CENTERVILLE CITY PLANNING COMMISSION AGENDA

Short Title: ADMINISTRATIVE DECISION - Public Hearing - Preliminary Subdivision & Final Site Plan - The Lane

Review Preliminary Subdivision and Final Site Plan submittals for twelve unit Residential-Medium project located at approximately 644 West Porter Lane.

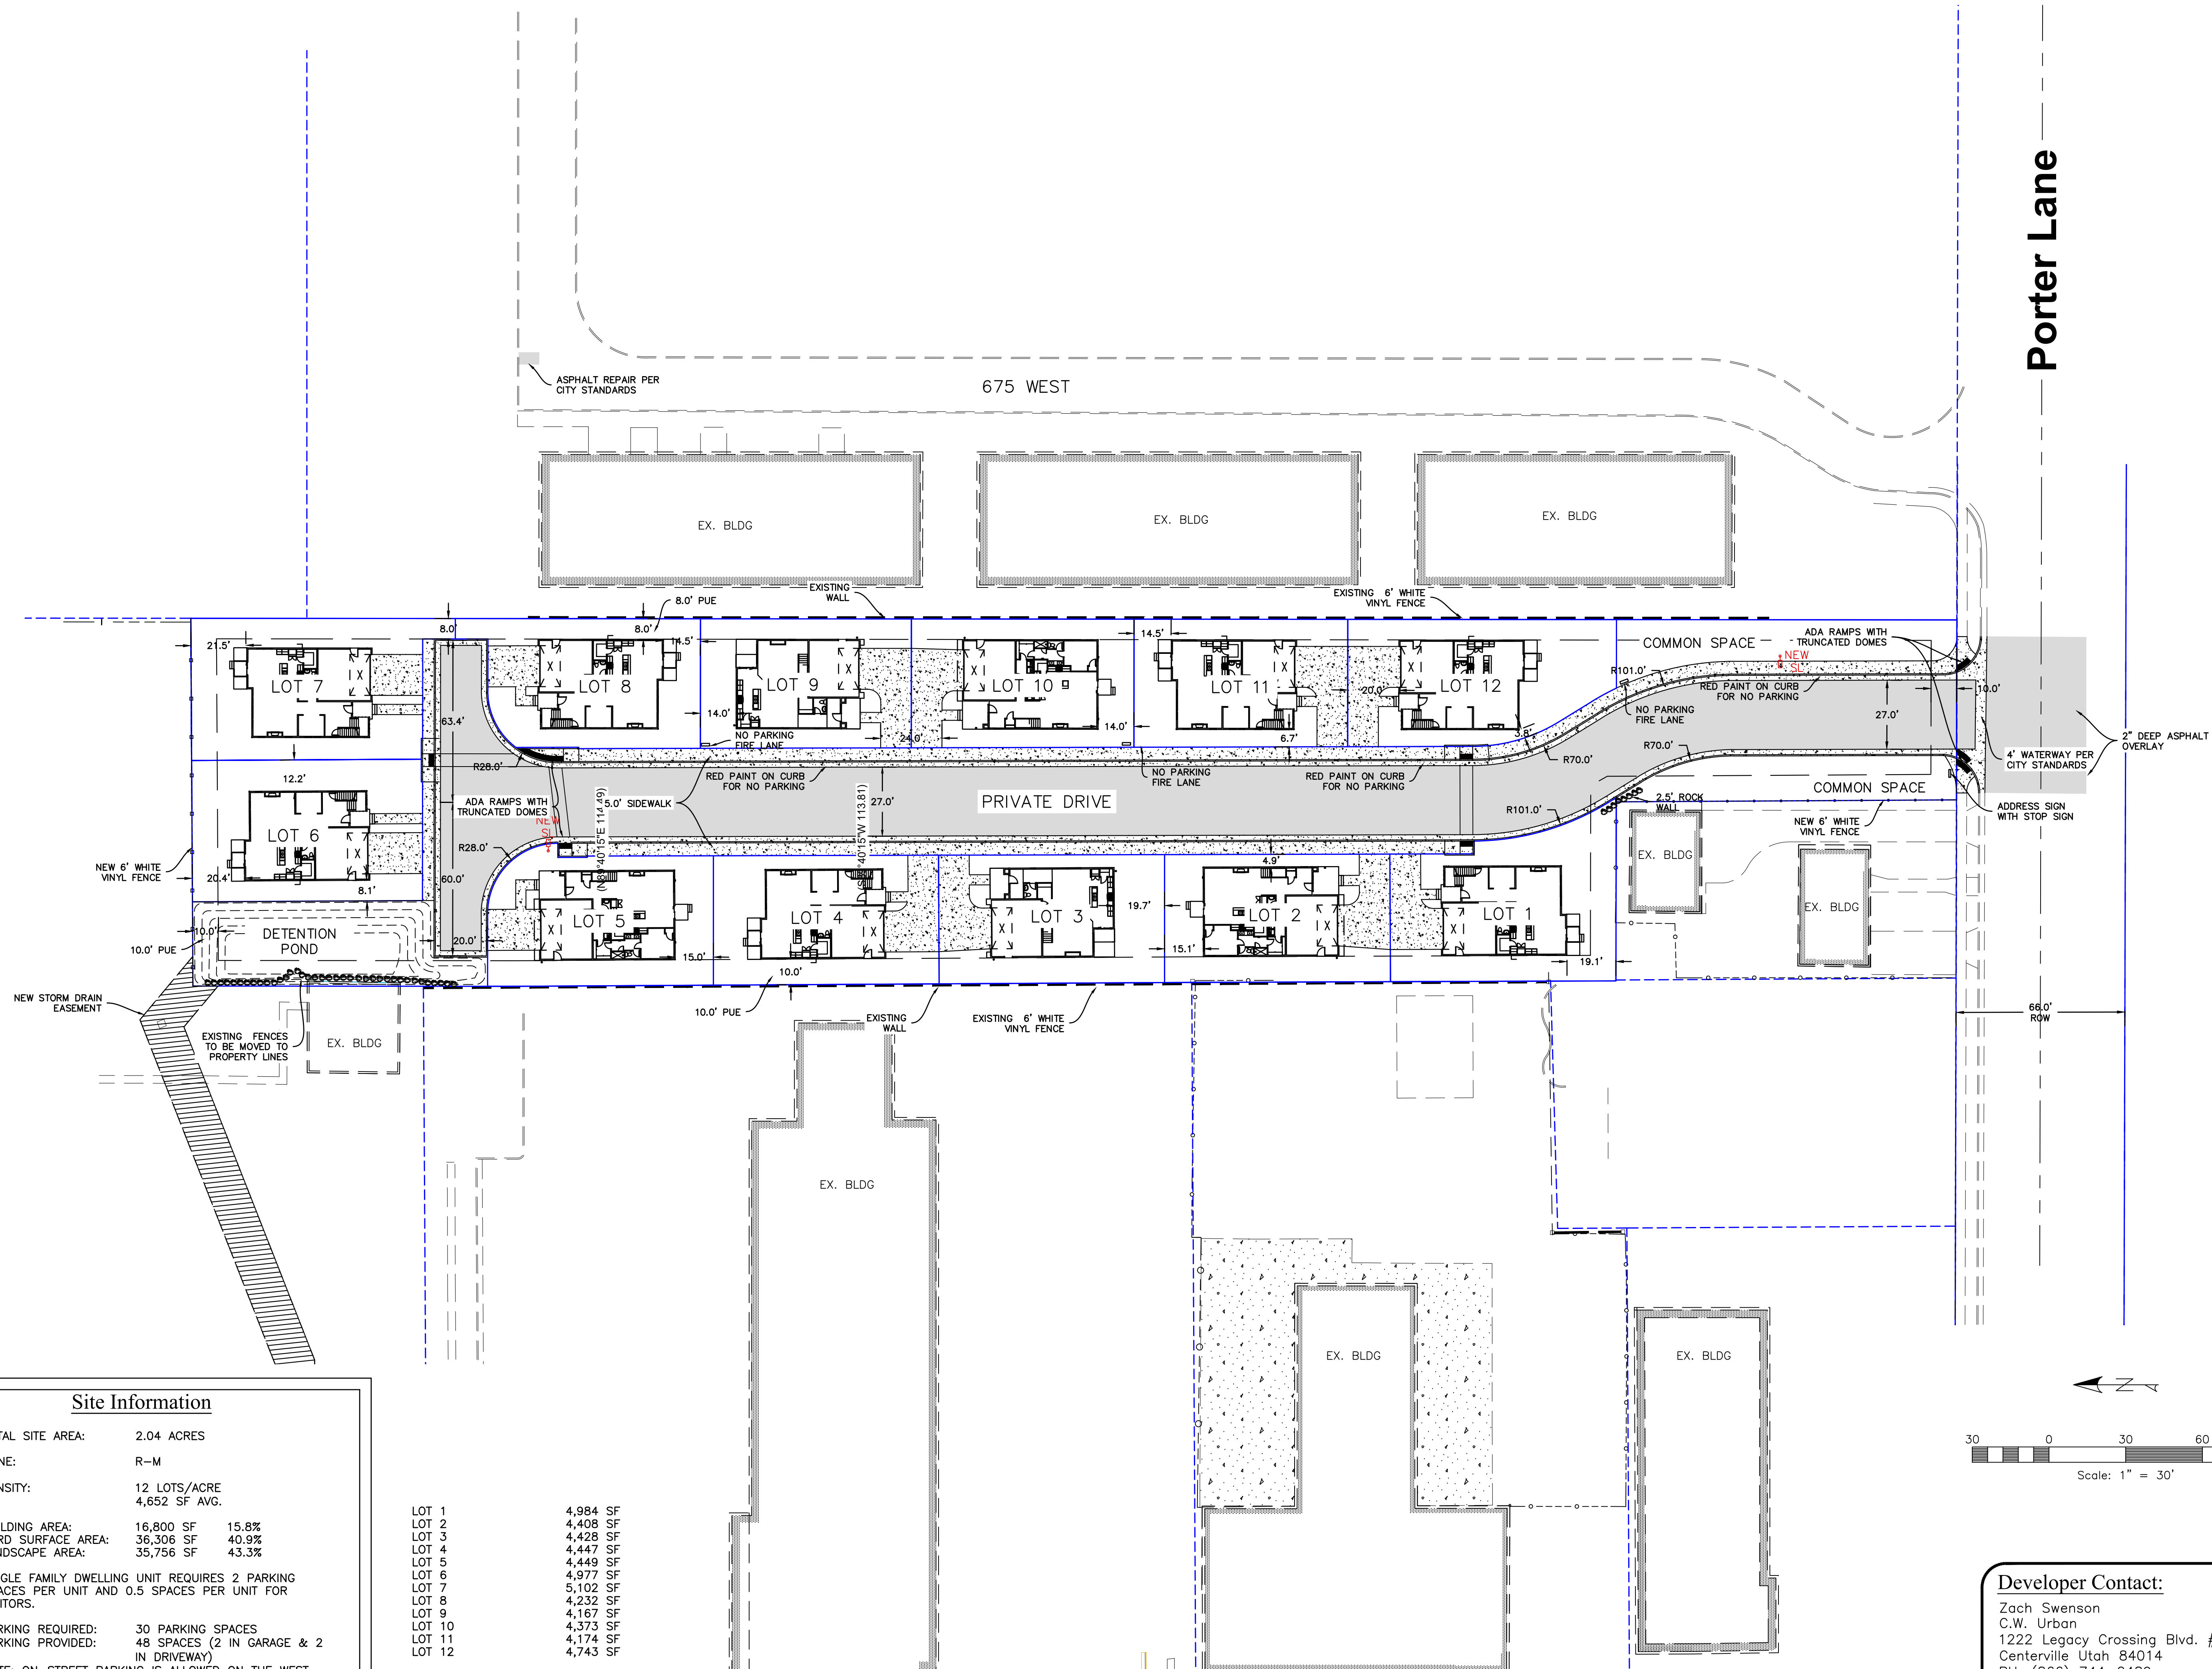
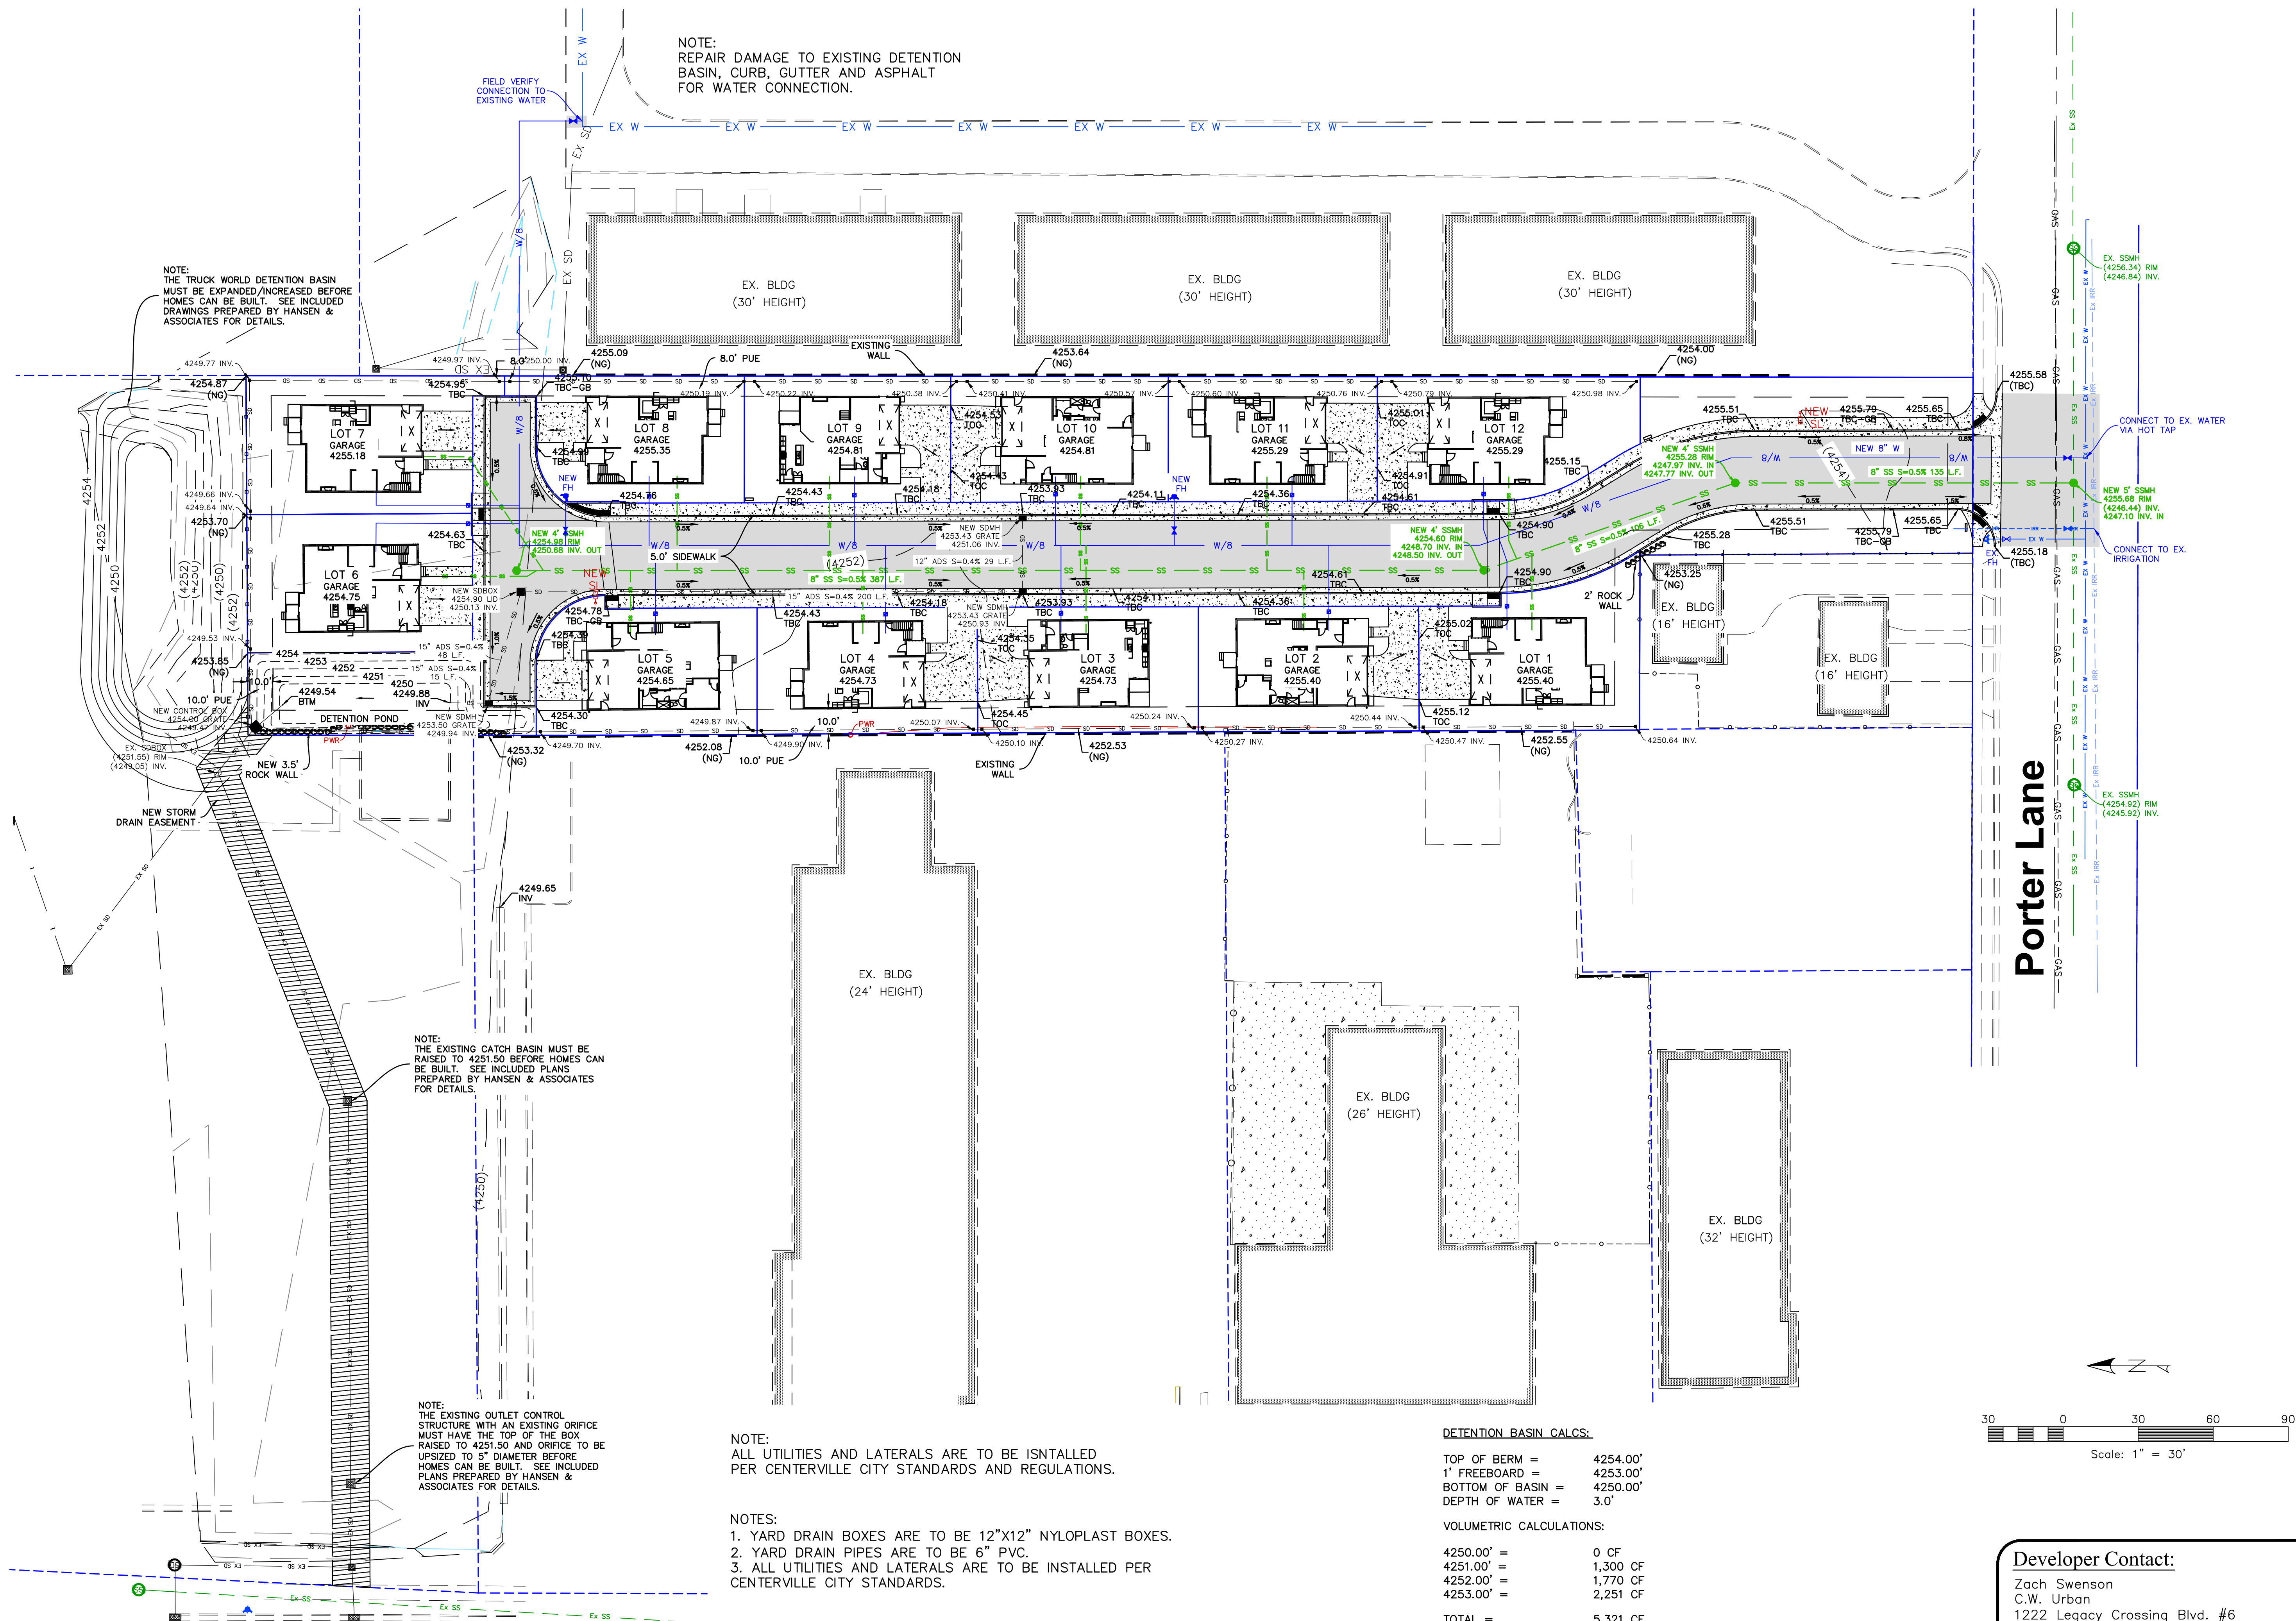
- a. Lot 7 has been moved south to comply with the 20' rear yard setback. It now sits 21.5' from the northern property line
- b. The private lane has been expanded to meet the required 27' of pavement. This has been accomplished by removing the western portion of the sidewalk at the entrance to the subdivision, and the addition of a pedestrian crosswalk parallel with the first set of homes.
- c. The applicant has provided civil drawings (sheet 5 of 10) that include the drainage to the Frontage Road. The City Engineer has been invited tonight to address any Planning Commissioner questions on the drainage.

Staff Response: An exception is built into the Code about sidewalks on both sides of a private lane. Sheet 4 shows the amended sidewalk. There will be sidewalks on both sides where the houses are, but only one sidewalk into the development. It is the Planning Commission’s discretion if the updated site plan meets this section of code.
